ITEM FOR ENVIRONMENTAL COMMISSION AGENDA

NAME & NUMBER OF PROJECT: HCA Behavior Health Hospital
SP-2022-0516C

REQUEST: Variance request is as follows:
Request to vary from LDC 25-8-342 to allow fill to 14 feet.

Development Services Department
Staff Recommendations Concerning Required Findings

HCA BEHAVIORAL HEALTH
2411 PARK BEND DRIVE
CITY OF AUSTIN, TRAVIS COUNTY, TEXAS
SITE CUT-FILL EXHIBIT

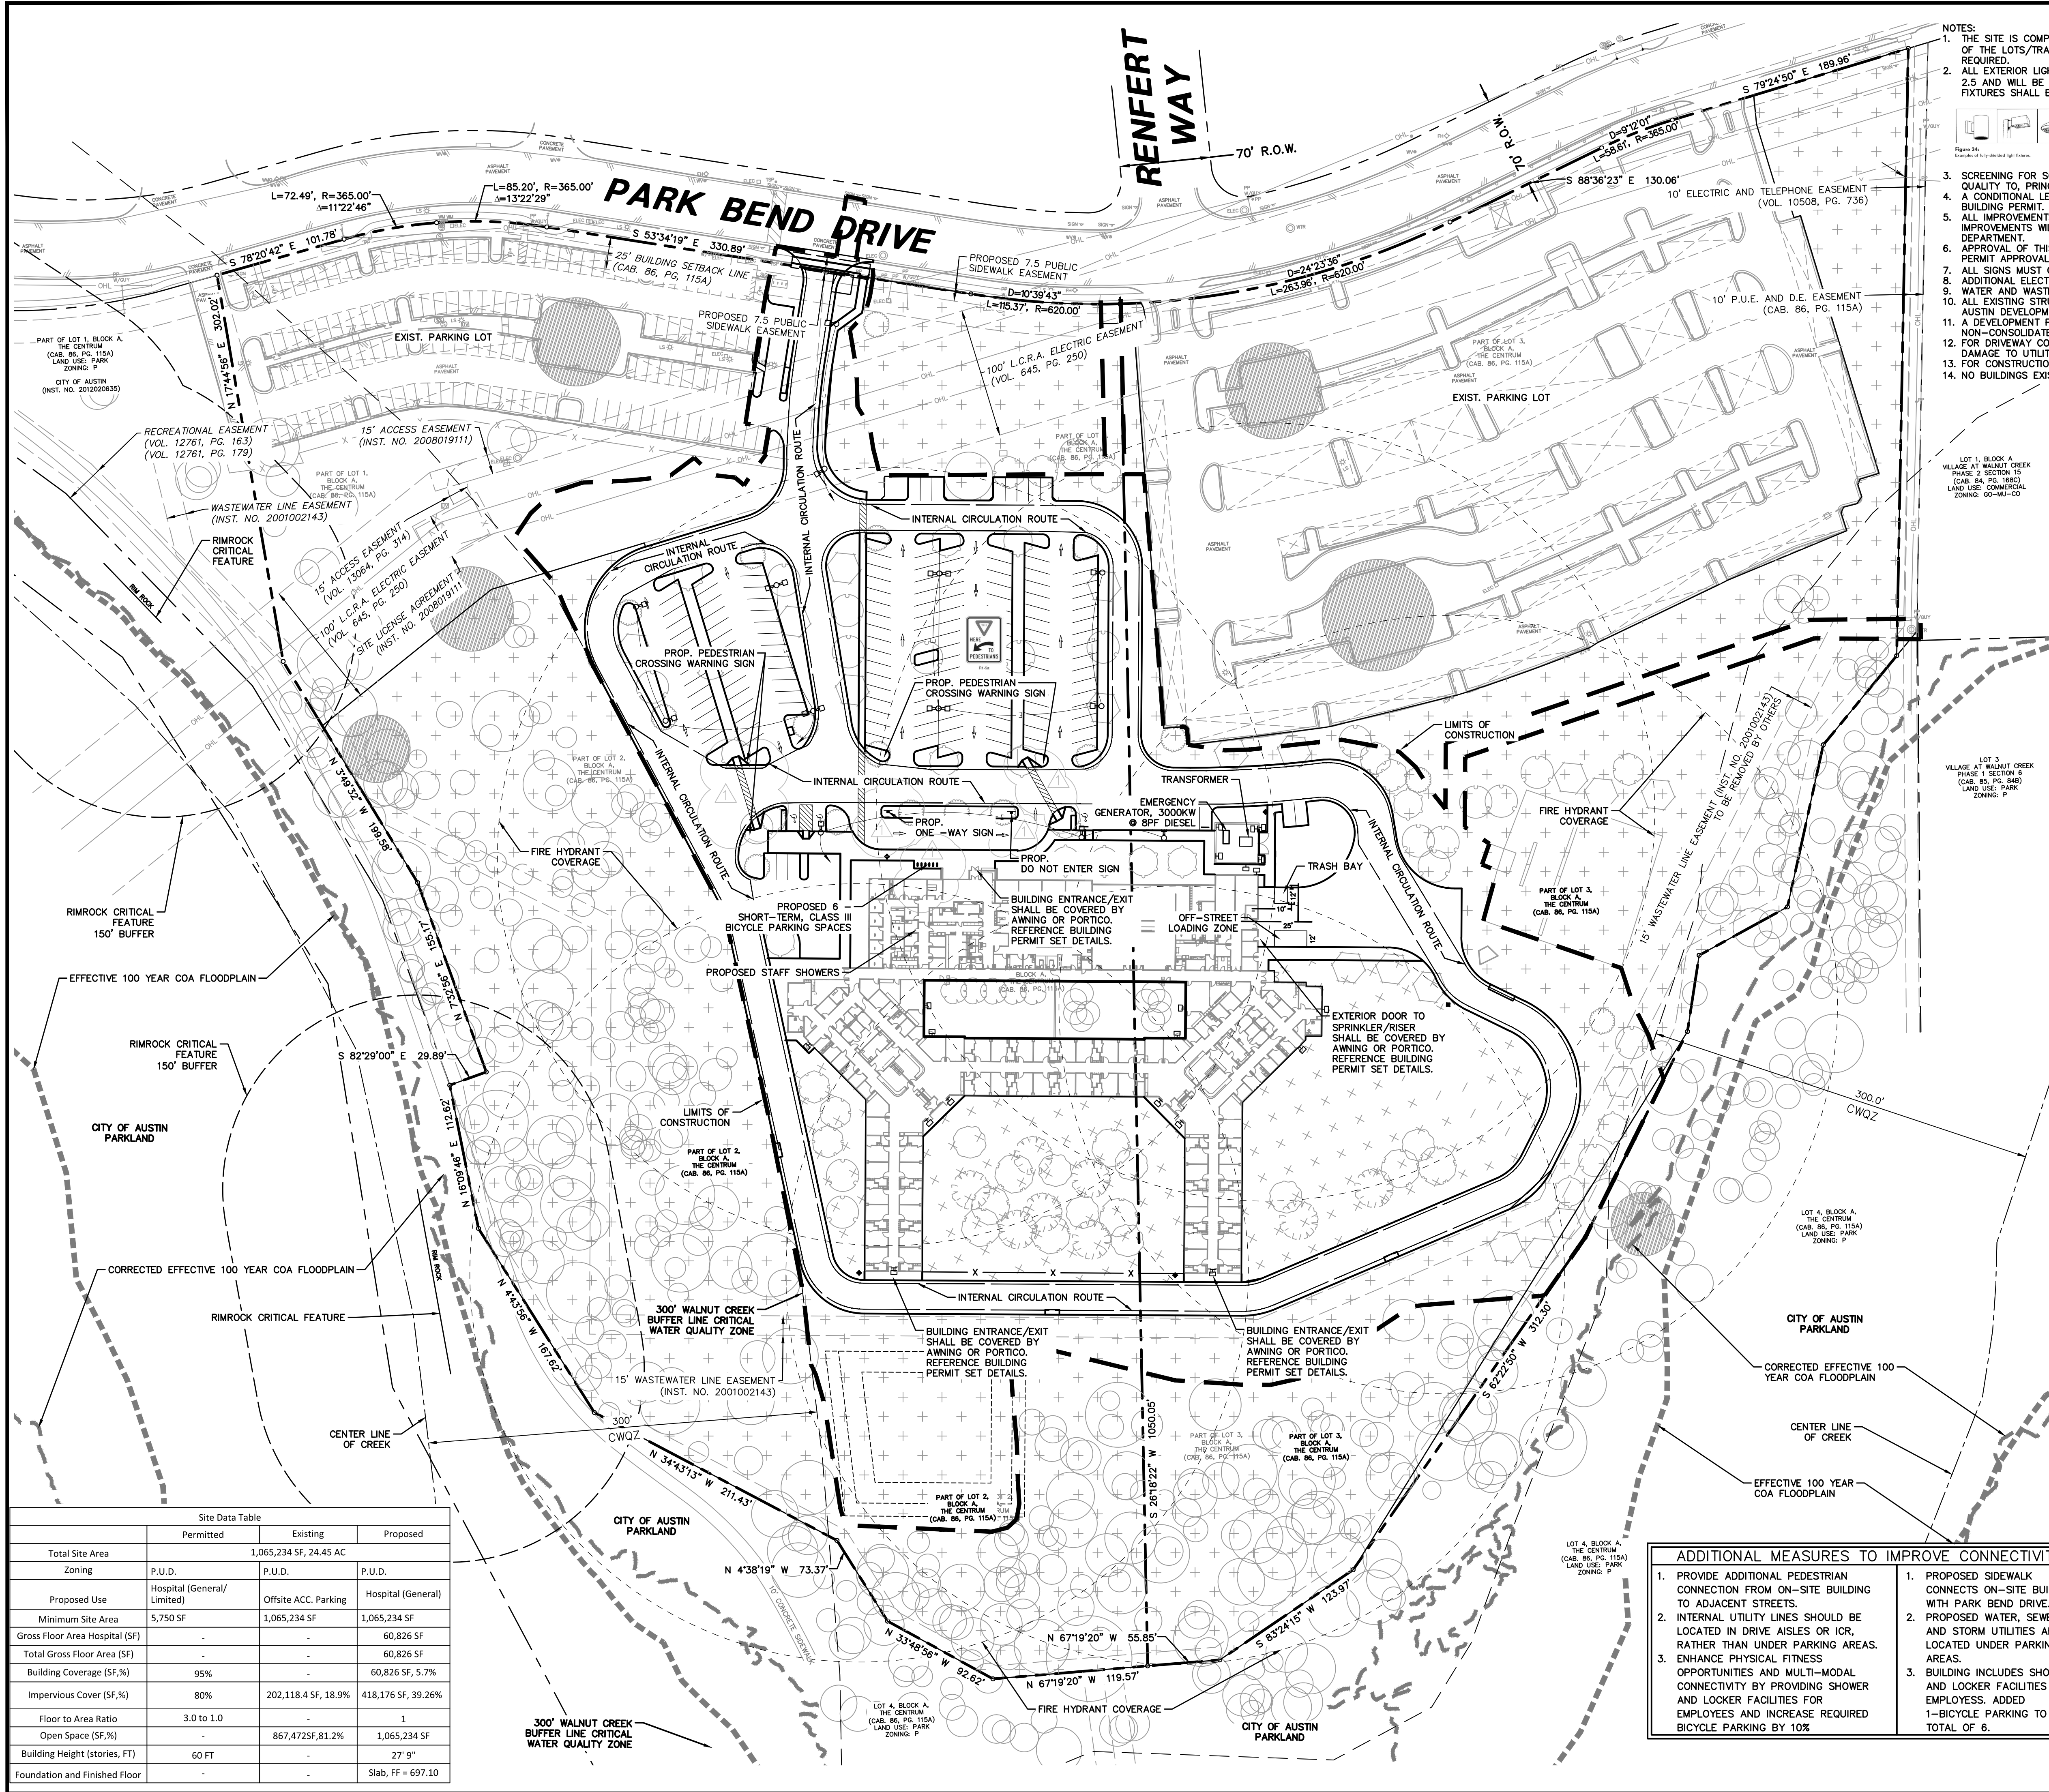
Clearly indicate in what way the proposed project does not comply with current Code (include maps and exhibits)	The proposed site development includes fill greater than 4' (max fill is 13.1')
---	---

1. Contain the fill with a combination of engineered walls and terraces to reduce grading and increase infiltration.
2. Seed and plant the terraces with native trees (where feasible based on structural constraints), perennials, grasses, and forbs per 609S to increase infiltration, provide habitat, and increase plant diversity. Providing NO MOW signage for the terraces.

1. Contain the fill with a combination of engineered walls and terraces to reduce grading and increase infiltration.
2. Seed and plant the terraces with native trees (where feasible based on structural constraints), perennials, grasses, and forbs per 609S to increase infiltration, provide habitat, and increase plant diversity. Providing NO MOW signage for the terraces.
